**ATTACHMENT A**  
**BLM COMMENT RESPONSES**  
**WITH EXTENDED NARRATIVES**  
**MARCH 31, 2017**

**BLM GENERAL 5**

UDWRe **Figure 2-5** MWH

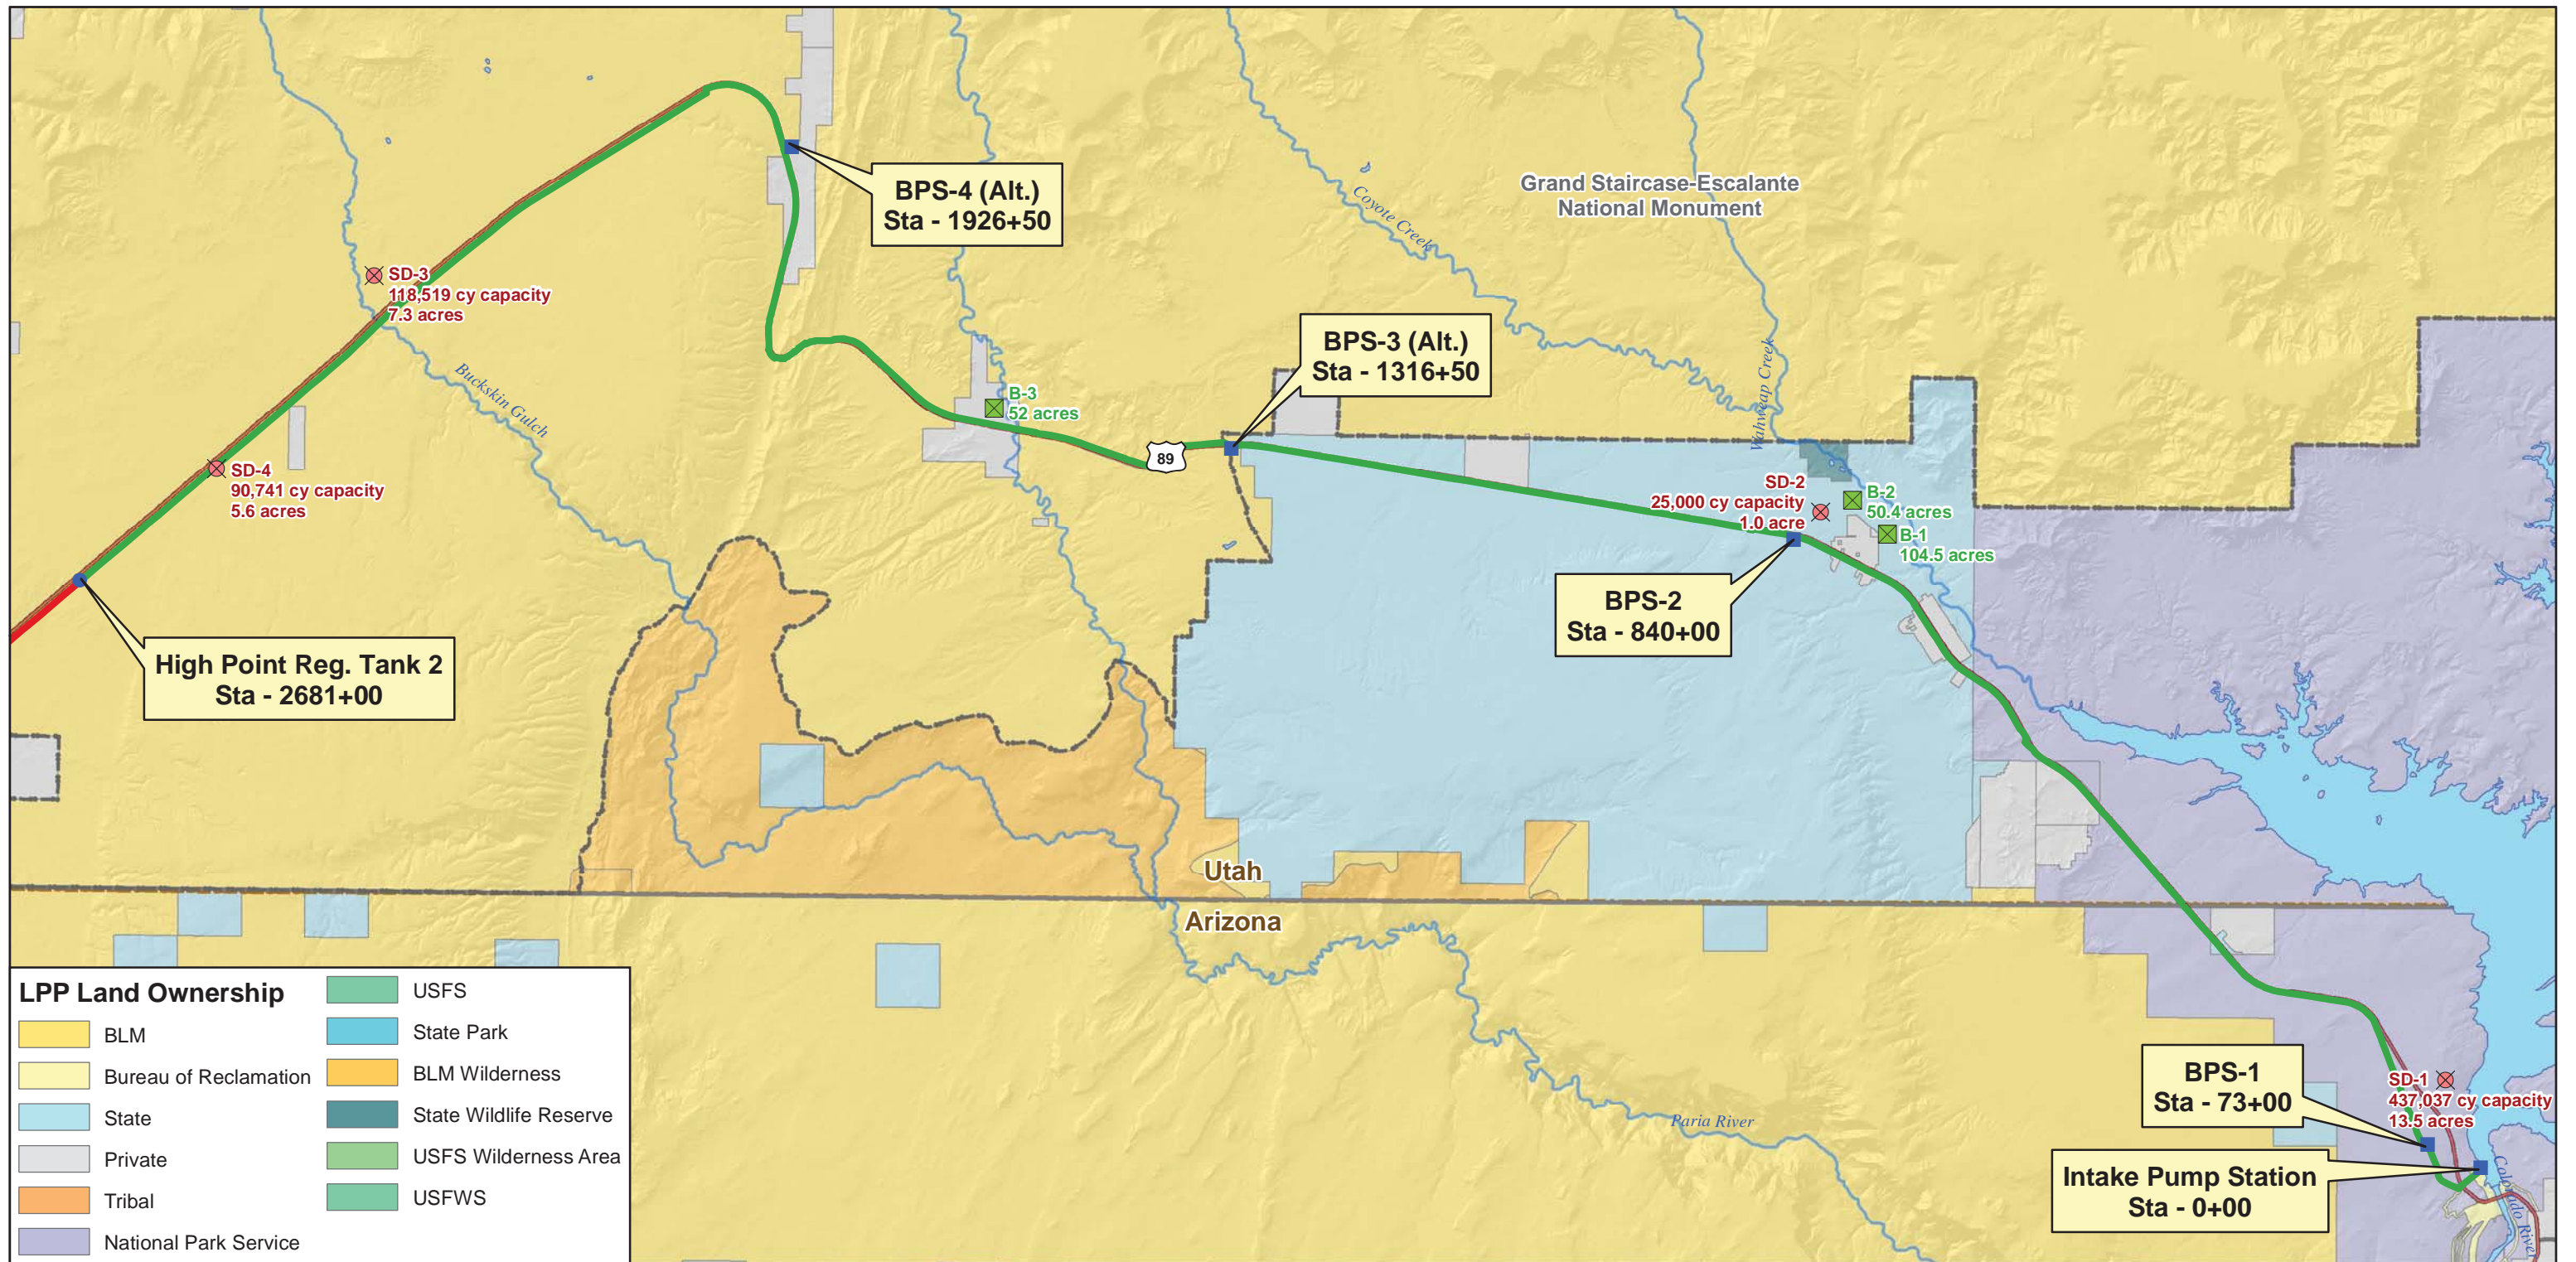
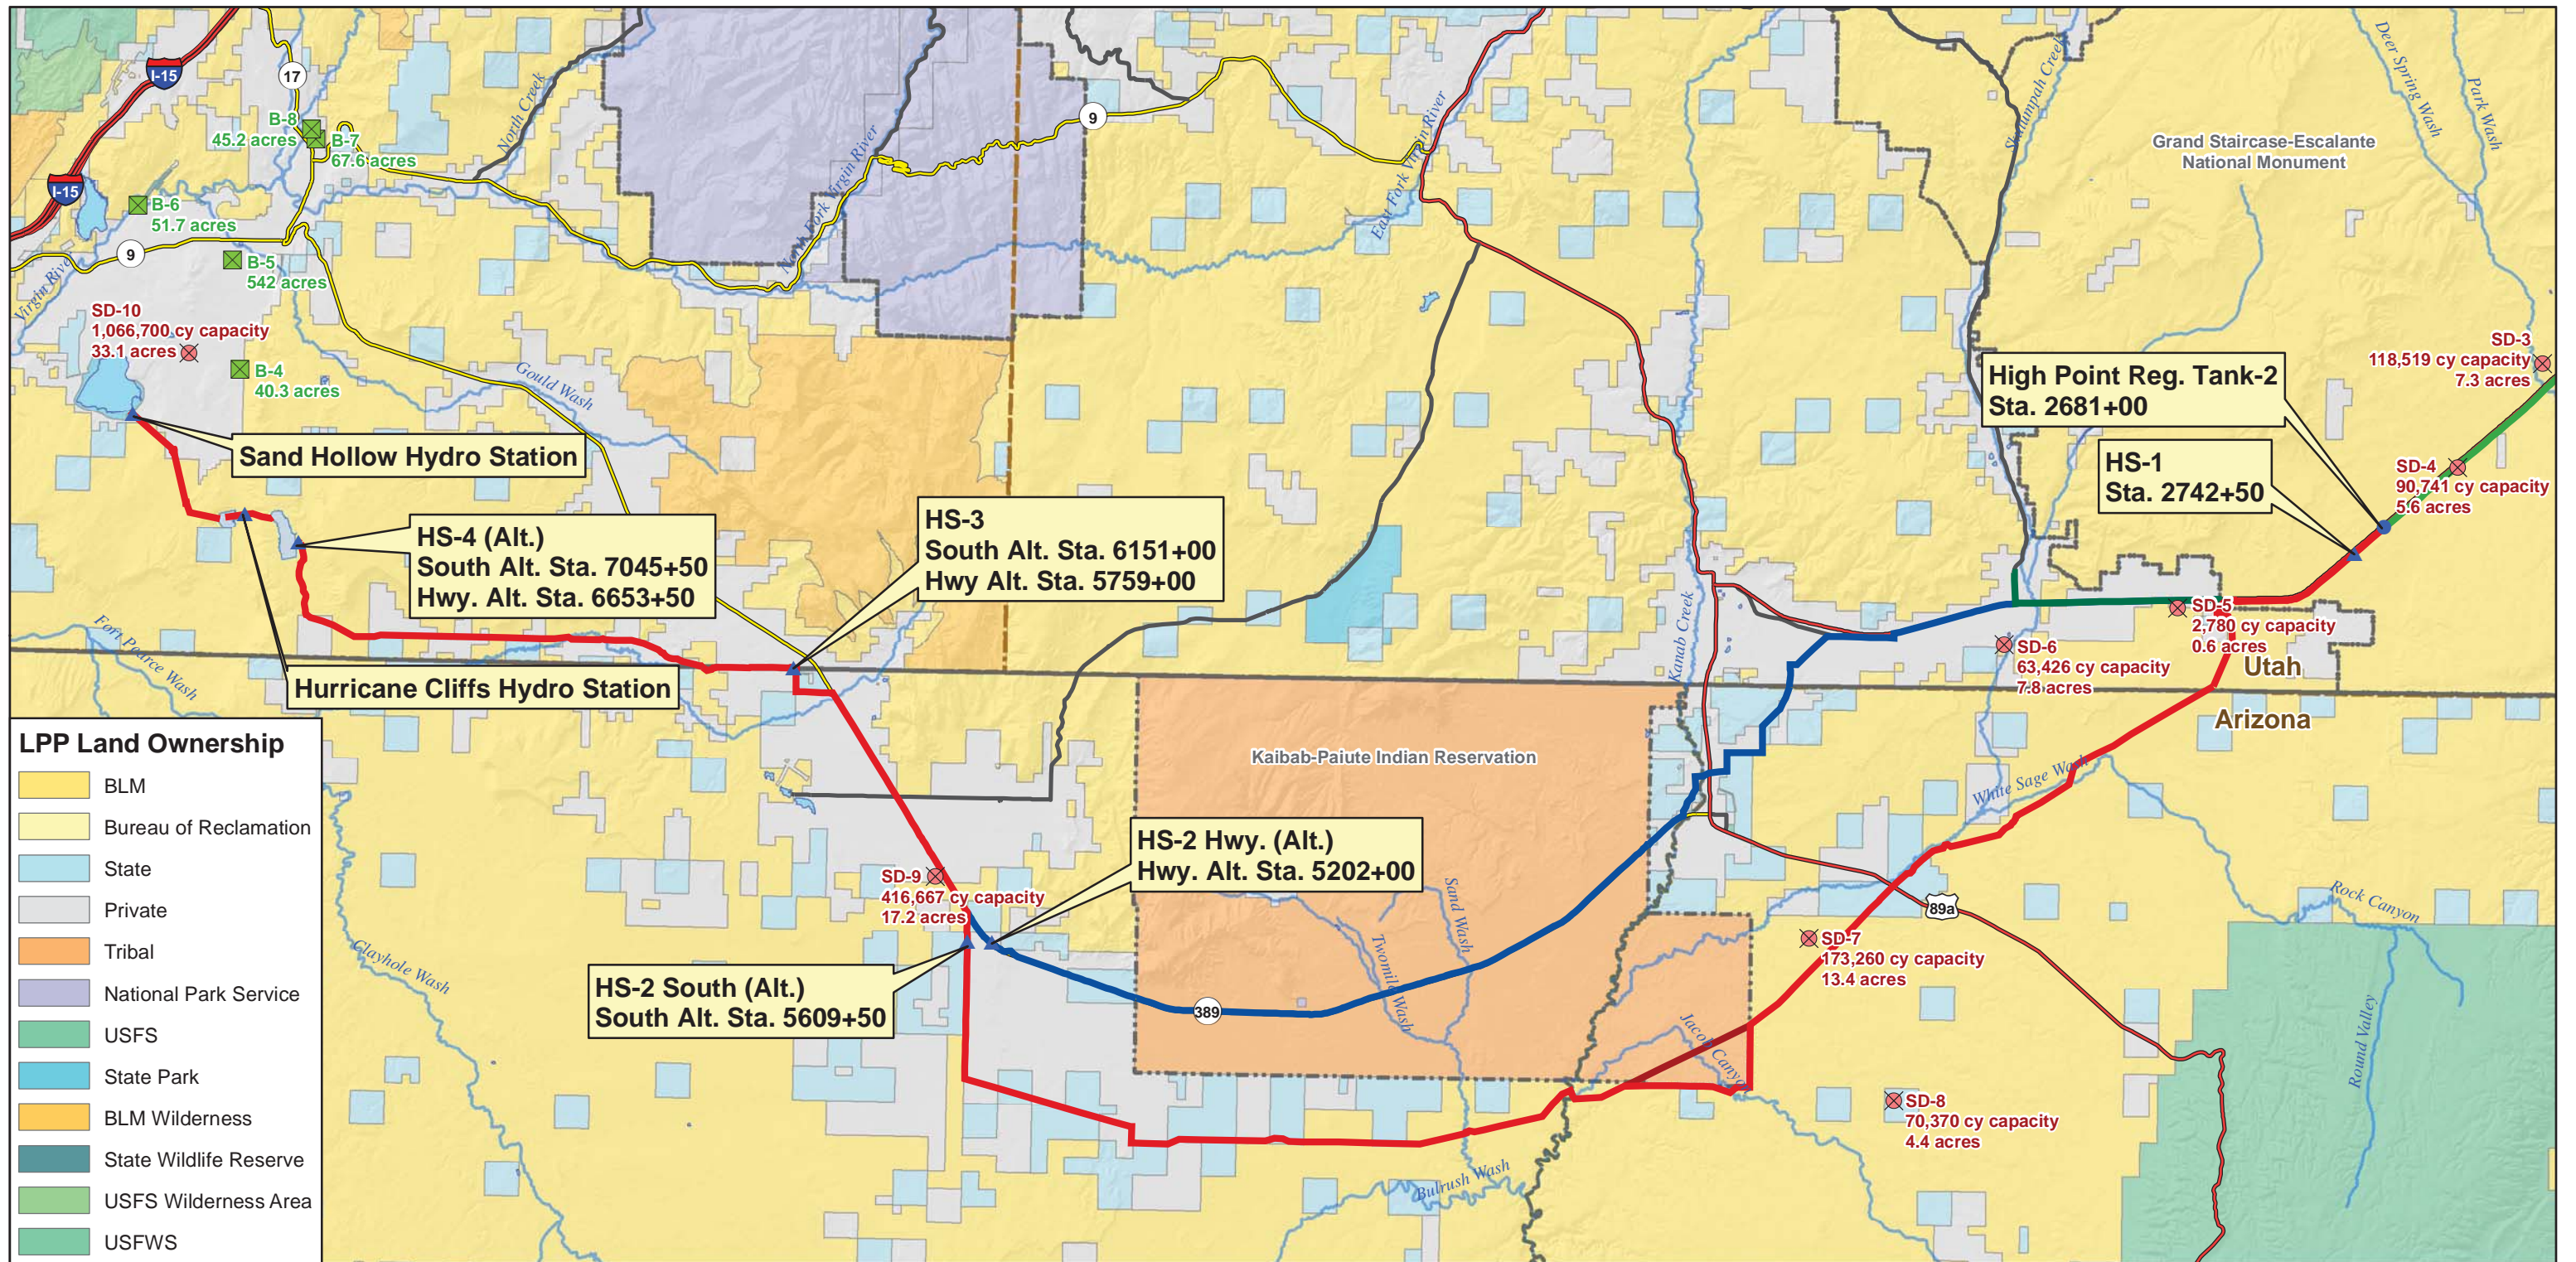
**(Figure 2-5 responds to BLM Comment No. 522)**  
**(Figure 2-6 responds to BLM Comment Nos. 522 and 541)**
